TRANS/WP.29/GRE/2001/31/Add.1 24 January 2002

World Forum for Harmonisation of Vehicle Regulations (WP.29)

### PROPOSAL FOR DRAFT AMENDMENTS TO REGULATION No. 48

## Addendum 1

# EXAMPLES OF LIGHT SOURCE OPTIONS

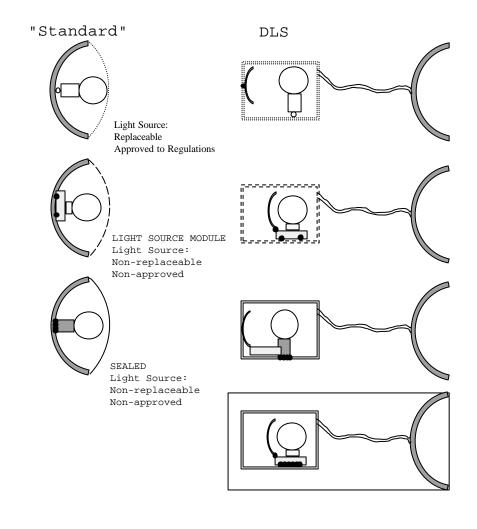
Insert new annex 10 and add a footnote referring to it to paragraphs 2.7.1. and 2.7.27., to read as follows:

Insert new annex 10, to read:
